Differential-mode to Common-mode and Common-mode to Differential-mode reflection specifications.

In support of 802.3dj D2.0 comments 492, 493, 494,
802.3dj July 2025. D

Mike Dudek Marvell

Figure 178-5—Receiver differential-mode to common-mode return loss limit

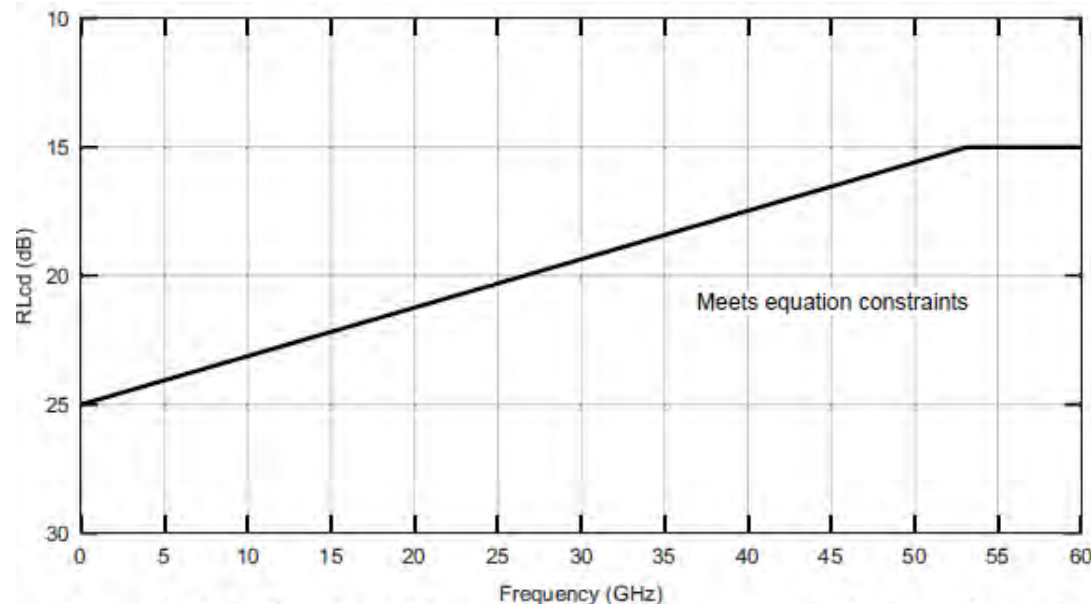
- There is no specification for SDC22 for the transmitter. Could be 100%
- No minimum loss is specified for the channel. Could be zero.
- Therefore the effective signal to noise ratio is only SCD11 of the receiver which is inadequate, particularly for C2C

- Per Comment # 494. Add a specification to the KR Transmitter for Common-mode to Differential-mode reflection with the same equation as is used for Differential-mode to Common-mode reflection for the Rx.
- Note:- Other comments have suggested adding a minimum loss to the KR channel. This would also help this issue.

Figure 176C-6—Receiver differential-mode to common-mode return loss limit

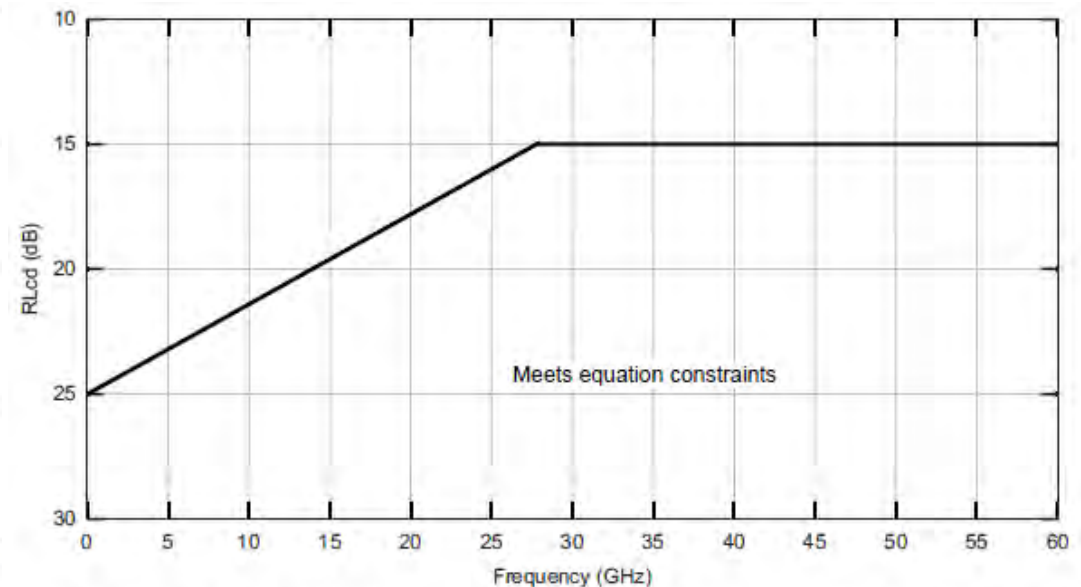
- Comment # 493 proposes to add a specification to the KR Transmitter for Common-mode to Differential-mode reflection with the same equation as is used for Differential mode to common mode reflection in the C2C Rx (176C-1), or with a more stringent specification for both,
- Note:- Other comments have suggested adding a minimum loss to the KR channel. This would also help this issue.
- Recommend that the more stringent specification Equation 178-4 (Figure 178-5) is used unless a significant minimum loss is specified.

Figure 179-8—Receiver differential-mode to common-mode return loss

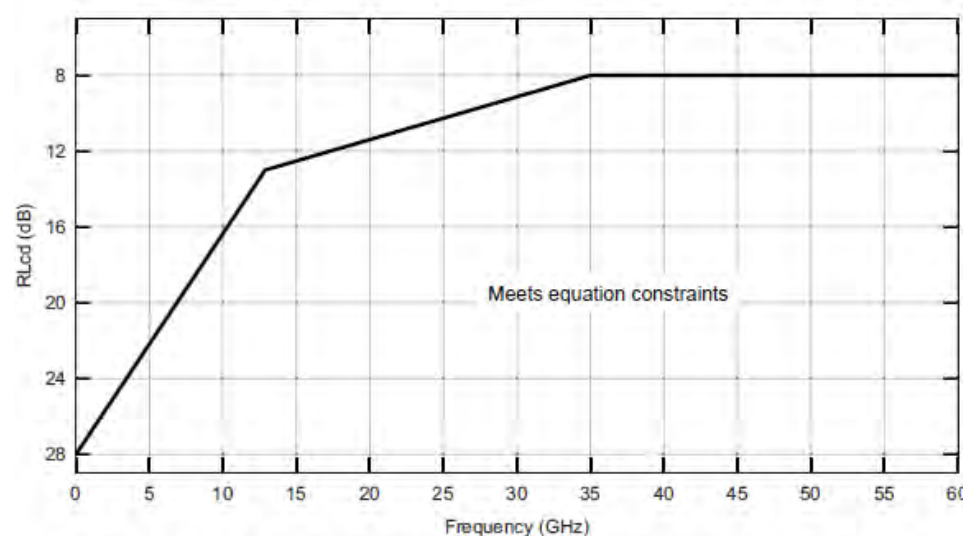
- The module and host have the same specifications for SDC22 of the transmitter and SCD11 of the receivers.
- There is no channel between these points.
- The resulting calculation would be only 16dB SNR at frequencies above 35GHz. In practice it is likely to be better than this as reflections at the MDI connector interface are being double counted.

- Per Comment # 492.
 - Change the specifications for these mixed mode reflections to 25-22(f/106.25) from 0.05 to 53.12 GHz and 19-10(f/106.25) from 53.12 to 67 GHz. This is the 802.3ck output common-mode to differential-mode reflection scaled in frequency.
 - Change the specification for the mated test fixture to 30-26(f/106.25) from 0.05 to 53.12 GHz and 22-10(f/106.25) from 53.12 to 67 GHz

Figure 179-8—Receiver differential-mode to common-mode return loss

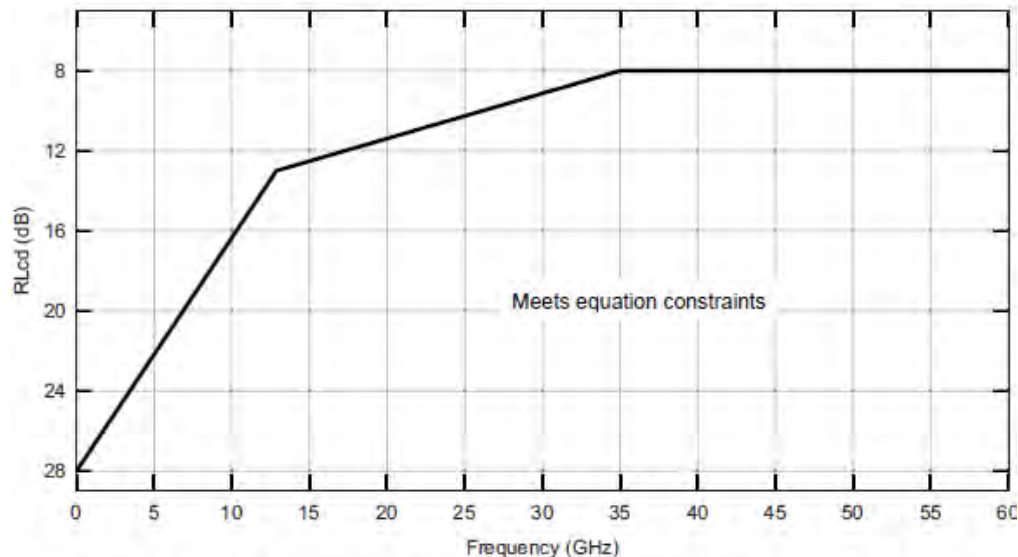
- Both SDC22 for the transmitter and SCD11 for the Rx are specified with same equation values and the same as C2M (see below).
- Differential minimum loss is specified for the channel as 16dB at Nyquist.(common mode is likely to be greater).
- Therefore the effective signal to noise ratio at Nyquist is 48dB. It is worse at lower frequencies (due to lower loss) but probably OK.

- The previous slide however looked at the situation from Tx to Rx. There is a much more serious issue at the interfaces between the Tx and the Cable (and the Rx and the Cable) where there is no loss to reduce the effect
- The Cable Differential-mode to Common-mode return loss is the same weak specification as shown in Figure 179-8.
- The resulting calculation would be the same as C2M. Only 16dB SNR at frequencies above 35GHz, although in practice likely to be better as reflections at the MDI connector interface are being double counted.
- Recommend to change the equations for Tx Common-mode to differential return loss, Rx differential-mode to common-mode return loss and cable differential-mode to common-mode return loss to the same equation as proposed for C2M
